Town Planner  
City of Karratha

## **RE: Multi Dwellings – 51 Gregory Way - DA25-068 - Amended Planning Approval**

**West Block – Overall building Height**

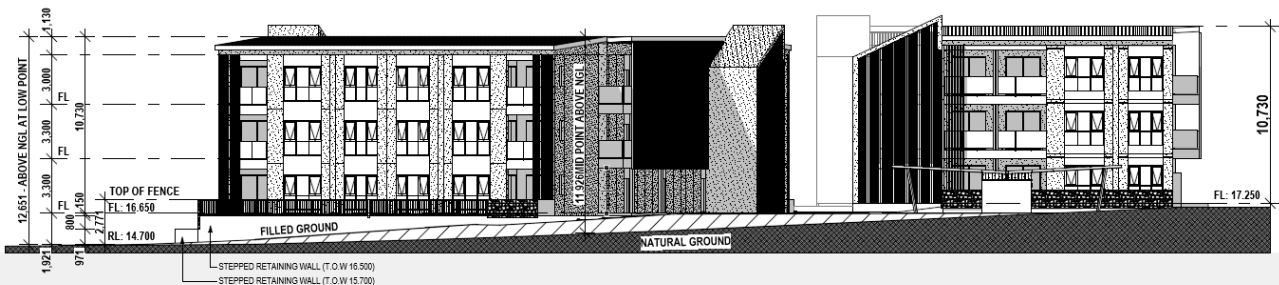
Building height above natural ground level has been raised due to the need for the retaining wall. The average height of the West Block is 11 926mm to ridge. The average overall height being 3 926mm over the 8m height for skillion rooves are per “R” codes Figure 3.2b

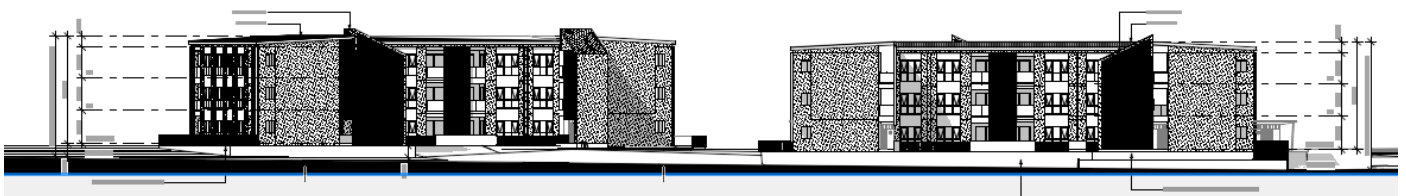
Building height above natural ground level has been raised due to the need for the retaining wall. The average height of the West Block is 11 580mm to ridge. The average overall height being 3 580mm over the 8m height for skillion rooves are per “R” codes Figure 3.2b
